Reviewers' comments:

The manuscript by Seeger et al. investigated approaches to filter the impulse response in optoacoustic microscopy (OAM). This is an important but challenging task, because the impulse response in a OAM contains responses from both optical and acoustic aspects of the system. If an universal algorithm could be developed, it will certainly benefit the optoacoustic research field. However, reviewer has three major concerns regarding the work:

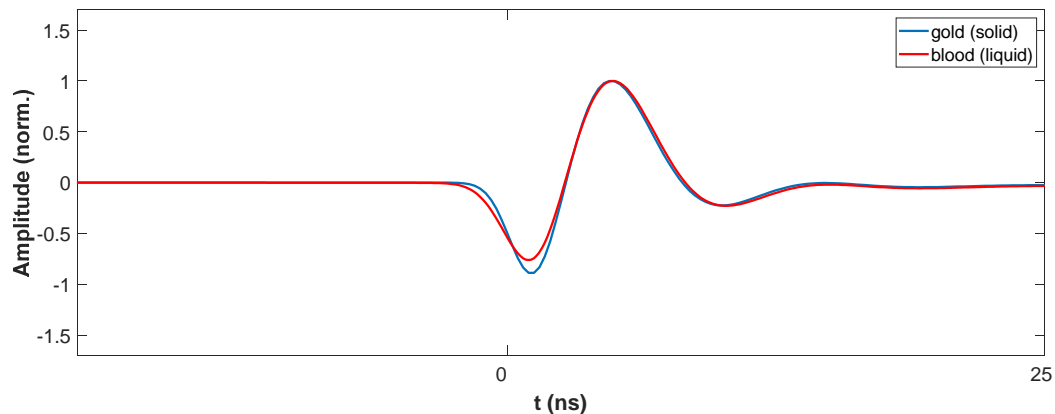
3. How does the presented approach differs from "scanning of an optical focus across an absorber plane", which is said then to "not generate a pattern of proper 3D optoacoustic point sources" (l.136-138)? I assume the authors are referring to the much larger axial thickness of the generated point source because weaker absorbing material was used in ref.33, but it should be clarified to avoid confusion.

We thank the reviewer for the pointing out this confusing statement. We modified the mentioned sentence in l. 143-146: *“Likewise, scanning of an optical focus across an absorber plane of non-negligible thickness (i.e. larger than half the theoretical axial resolution; $\sim 3\text{ }\mu\text{m}$ at signals of max 110 MHz; e.g. a slab of light absorbing material) would not generate a pattern of proper 3D optoacoustic point sources.”*

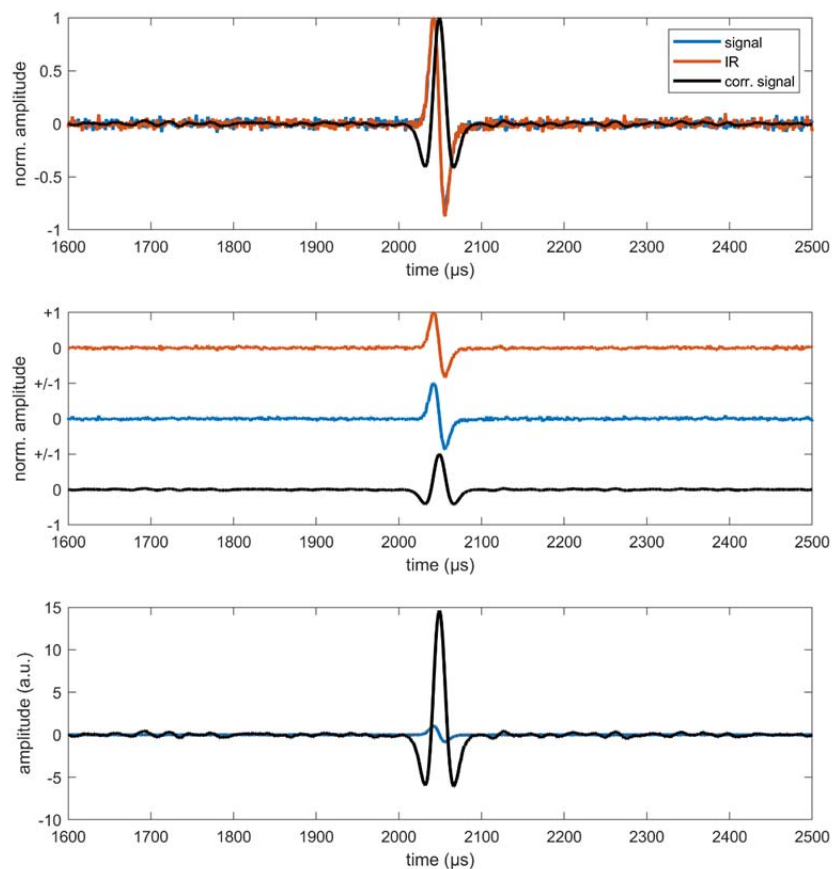
5. Moreover, the effect of the acoustic impedance mismatch between water and the gold layer is not mentioned, as it was for instance in ref.33. It could very much affect the final reconstruction, so it should be discussed at the very least.

3. Presumably the gold layer was deposited on a glass substrate and not free-standing. What about acoustic reflections and reverberations inside the glass substrate that might influence the impulse response?

In the figure below, the reviewer can find the simulation of the signal generated by a $1\text{ }\mu\text{m}$ solid diameter sphere made of gold, submerged in water and a $1\text{ }\mu\text{m}$ diameter liquid sphere filled with blood, assuming an instantaneous pulse and a transducer frequency range from 10 MHz to 120 MHz. The difference is minimal and probably stays within the noise level. We further added to l.495-498: *“Additional simulations of optoacoustic spherical sources of $1\text{ }\mu\text{m}$ size (solid or liquid; data not shown) indicate negligible differences in their associated signals, which further validates the usability of the GL as an emanation basis for optoacoustic point sources”*

We agree with the reviewer that some acoustic effects due to the multilayered composition of our gold plate arrangement (the arrangement was described in the methods section) might ruin the point like nature of the signal. In order to quantify such an effect, we compared the signal generated by our gold layer (plus titanium, plus glass; see methods), to the signal generated by a single microsphere (diameter = $1 \mu\text{m}$) embedded in agar (this was shown in results). Both signals were practically identical.

We further added in l. 495-498 “Additional simulations of optoacoustic spherical sources of $1 \mu\text{m}$ size (solid or liquid; data not shown) indicate negligible differences in their associated signals,

which further validates the usability of the GL as an emanation basis for optoacoustic point sources". See reviewer #2 point 5.

shown below as well as in the Supplementary Information as Fig. S8.

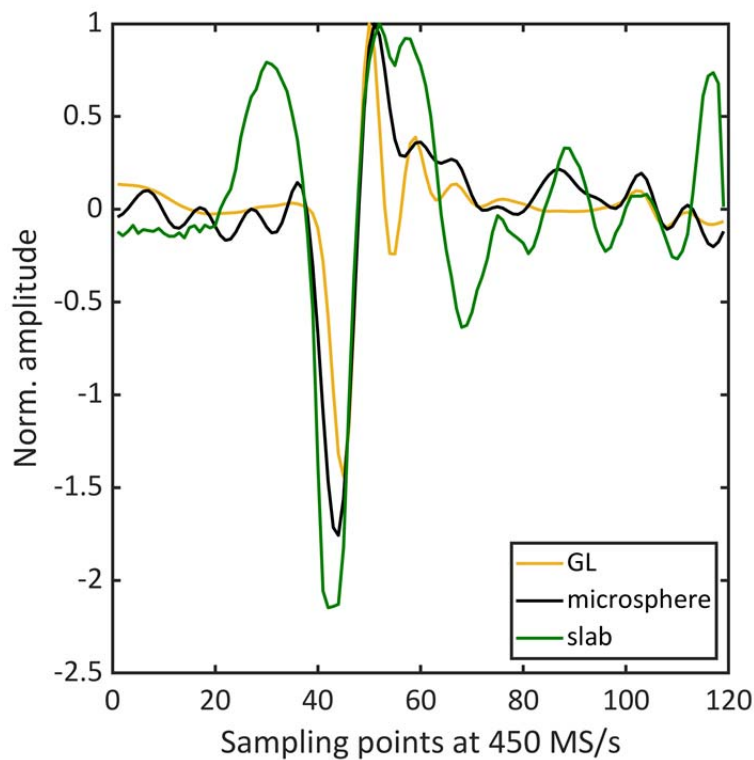
4. I agree with the authors that their comparison exhibit the better performances of their technique regarding SNR, but I still emphasise that a proper comparison between to signal should be carried out as well with similar SNR, even though this would not be used in practical scenarios.

Reviewer's initial comment: The shape of the signals either generated with the bead or with the locally illuminated gold nanolayer actually differ by some non-negligible amount. It would be better to compare the signals with similar SNR, before stating anything about the equivalence of the 2 measurements.

As explained in the initial review, the comparison between the GL and a microbead serving as possible point sources attempts to show that the GL leads to significantly better SNR when using the identical measurement parameters. To evaluate the similarity, we calculated the L2-Norm between the two specimens and updated the manuscript in l. 236-241: *We analysed the similarity between the signals recorded using the GL and the microsphere as possible point sources via the relative squared L²-error defined as $\frac{||Sig_{GL}-Sig_{microsphere}||_2^2}{||Sig_{microsphere}||_2^2}$ as it is invariant with respect to Fourier transform (Parseval's identity), which is relevant for the contained frequency content. Such analysis yielded a relative error of 0.28, whereas analogous analysis between the microsphere and a non-point source specimen (slab) yielded 0.90 (see supplementary information; Fig. S8).* The associated time-wise centered signals used for this analysis are
